Value Engineering

Final Report

Intake Diversion Dam Fish Protection and Passage Concept Design, Lower Yellowstone Project

July 29, 2002

Figure 15. Plan of Wall and Slab Eliminated

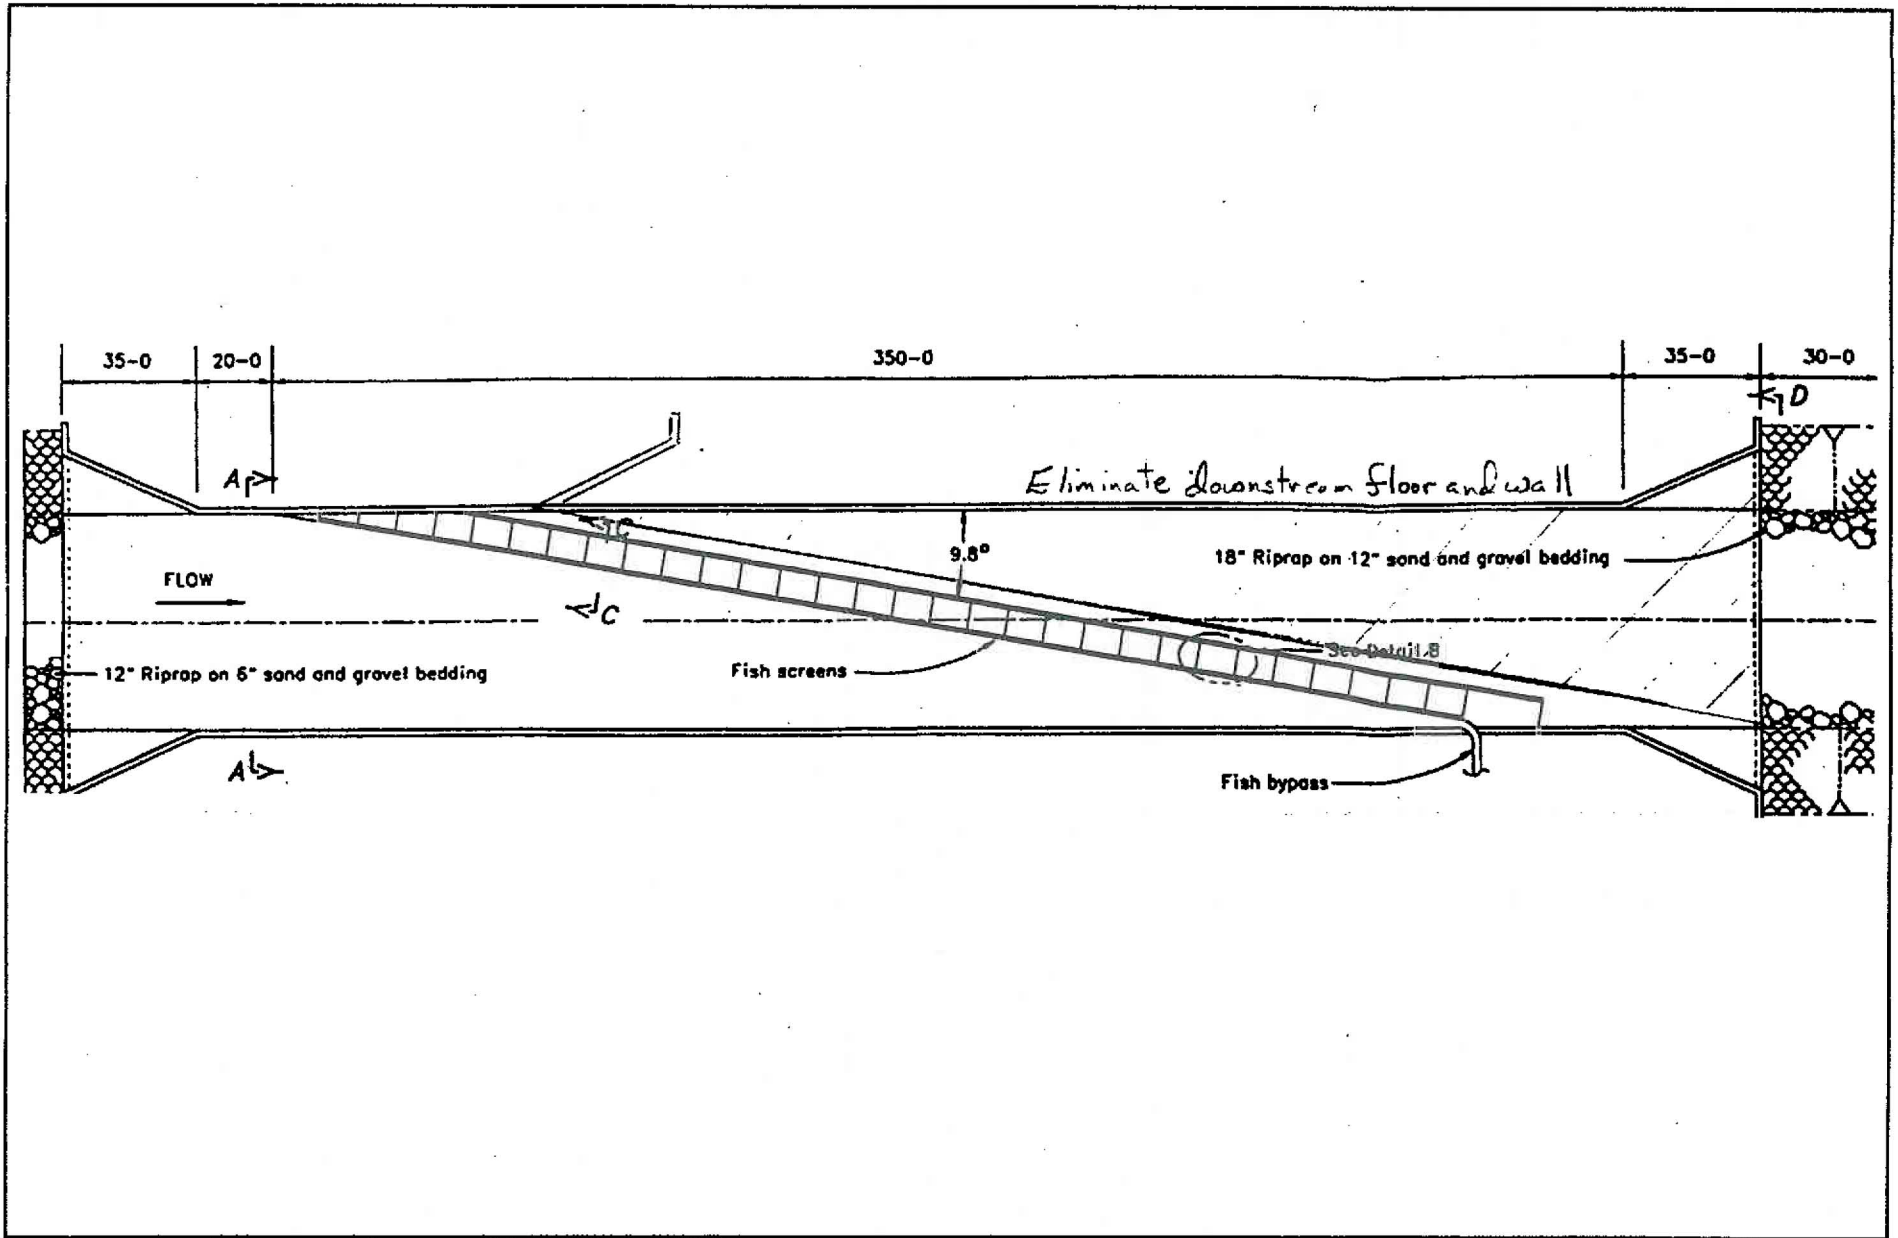
Proposal No. 5. Reduce Concrete in the Fish Screen Structure

- Proposal Description: This proposal would eliminate a section of concrete floor and wall downstream of the fish screens. The left side of the transition at the lower end of the structure would be relocated to just downstream from the upper end of the fish screen. The concrete floor of the canal would be reduced to only that needed for a foundation for the screen structure.
- Critical Items to Consider: Analysis may be performed to determine if bank armor and canal floor riprap are needed to control scour on the downstream side of fish screen.
- Ways to Implement: None noted.
- Changes from the Baseline Concept: This proposal would reduce the area of concrete.

Figure 16. Wall Section

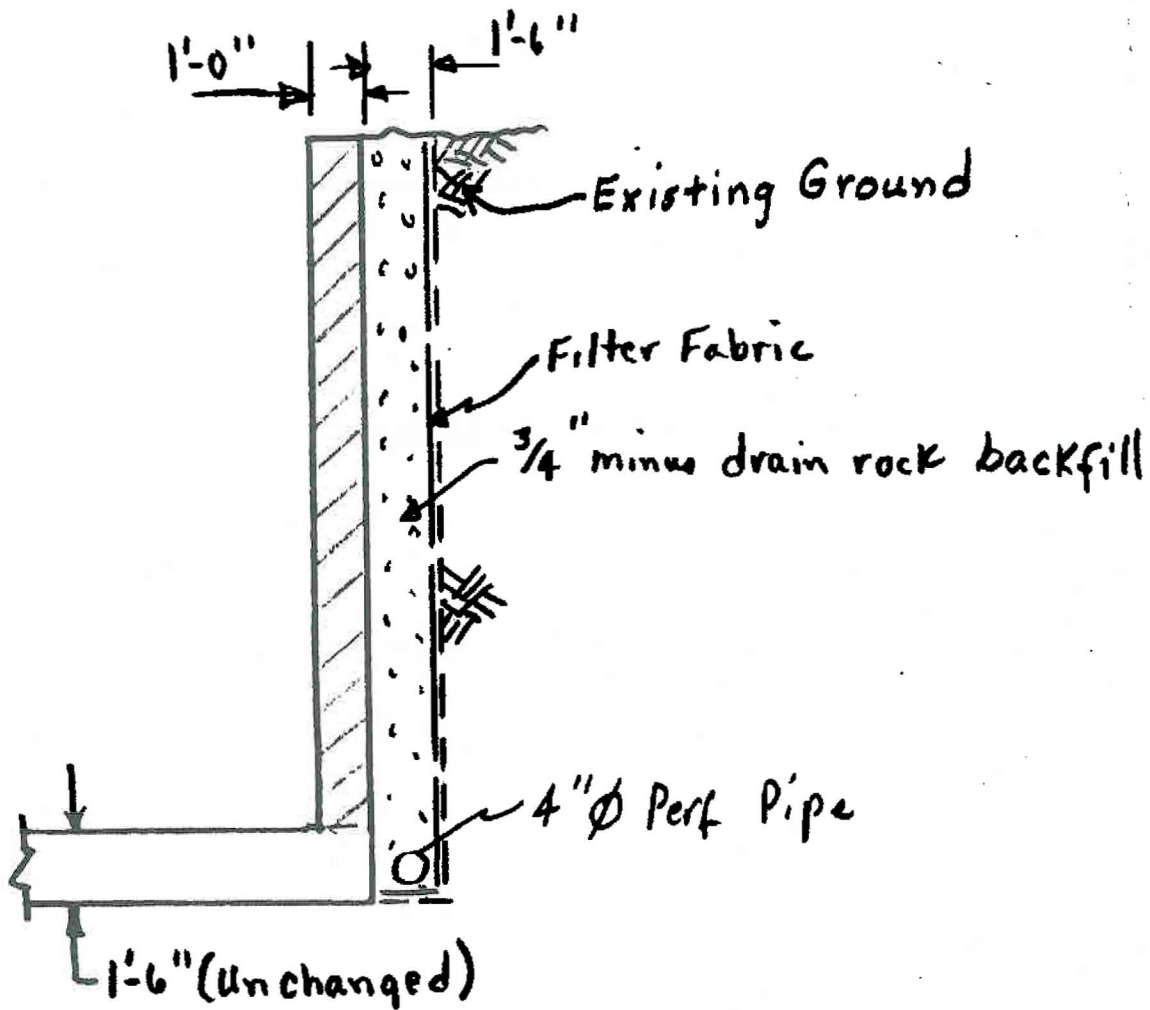
Proposal No. 7. Reduce Screen Structure Wall Thickness.

- **Proposal Description:** This proposal would reduce the thickness of concrete walls from 1 ½-foot to 1-foot. Freeze-thaw problems would be avoided by adding a 1 ½-foot-thick section of drain rock backed by a filter fabric. Water collected between the concrete wall and the filter fabric would drain through a 4-inch perforated pipe at the foot of the wall.

- **Changes from the Baseline Concept:** The major change is the replacement of thicker (1 ½-foot) walls with thinner (1-foot) walls backfilled with a layer of free drain fill and filter fabric. In the climatic conditions encountered at Intake, 1 ½-foot thick concrete is the baseline concept method of addressing freeze-thaw problems. The free drain fill and filter fabric combined with perforated pipe is designed to greatly improve drainage and allow the successful use of the 1-foot thick concrete.

Thickness changed from 1'-6" Base Proposal
